CALIFORNIA COASTAL COMMISSION

**STAFF REPORT: REGULAR CALENDAR****APPLICATION NO.:** 4-02-179**APPLICANTS:** Concord Enterprises, attn: George Shakiban**AGENT:** Gabriel Baron**PROJECT LOCATION:** 6275 Zumirez Drive, Malibu, Los Angeles County

PROJECT DESCRIPTION: Construction of a two-story, 26.5 foot high, 7,655 sq. ft. single family residence, with attached three-car garage, septic system, swimming pool and spa, fence, entry gate, driveway, motor court, sports court, and 667 cu. yds. of removal and recompaction.

EXHIBIT NO. 9
APPLICATION NO.
4-02-179
BUILDING PADS

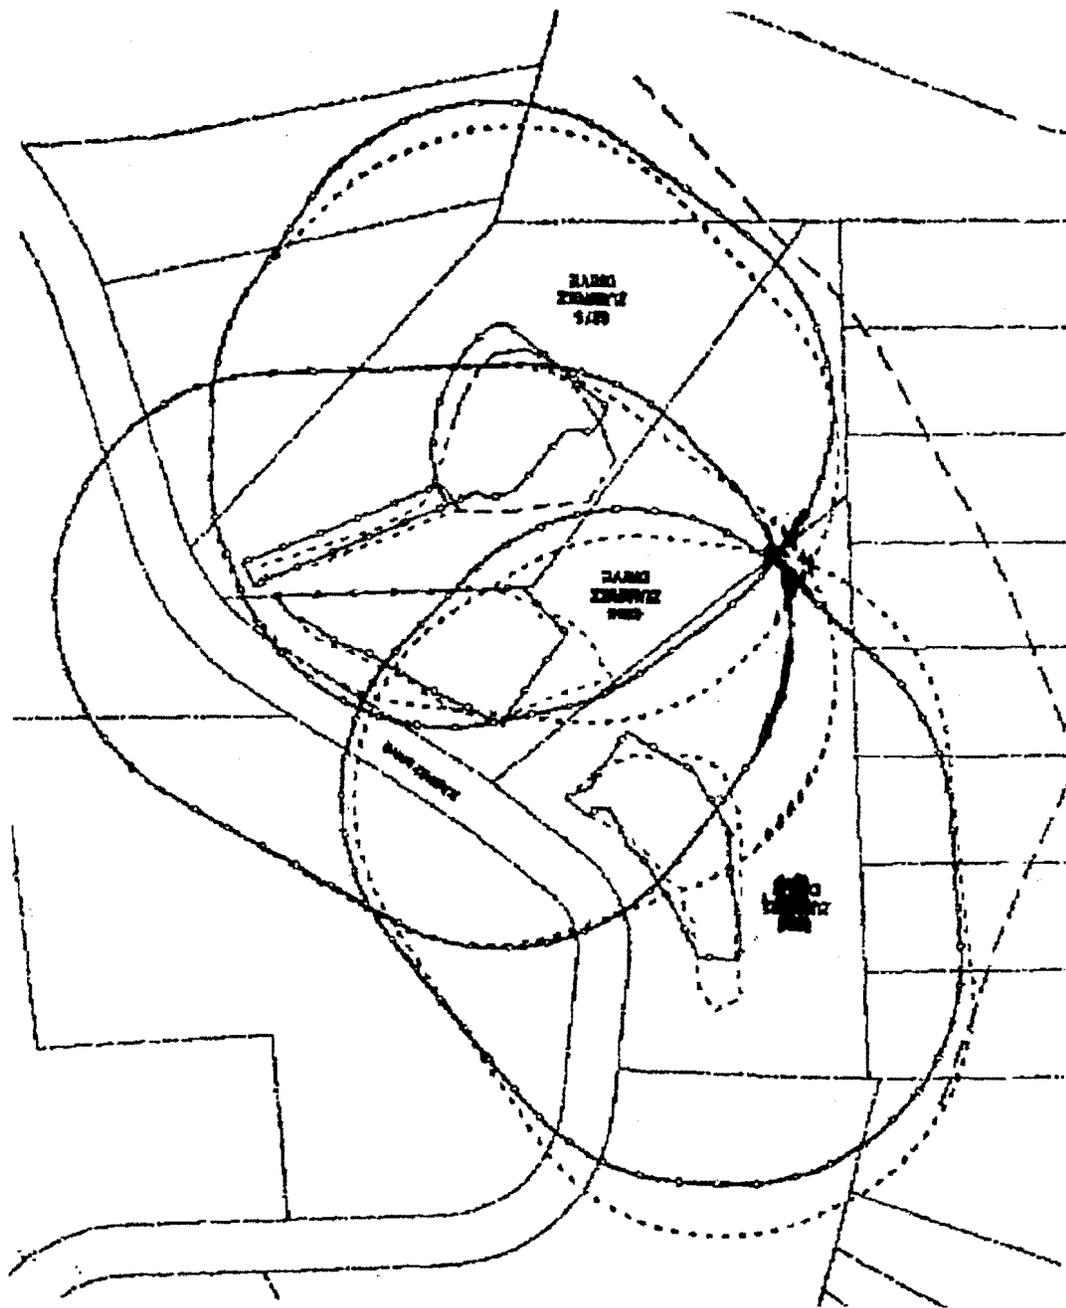
As noted above, the proposed development is located on an existing building pad previously approved by the Commission (5-89-1064, Assael). Although the as-built pad is located slightly north of the location approved under CDP 5-89-1064, it does not extend the development envelope further down the hillside, but rather pulls it back slightly, thus increasing the setback from Walnut Creek and the impacts on riparian and hillside vegetation due to brush clearance and fuel modification requirements.
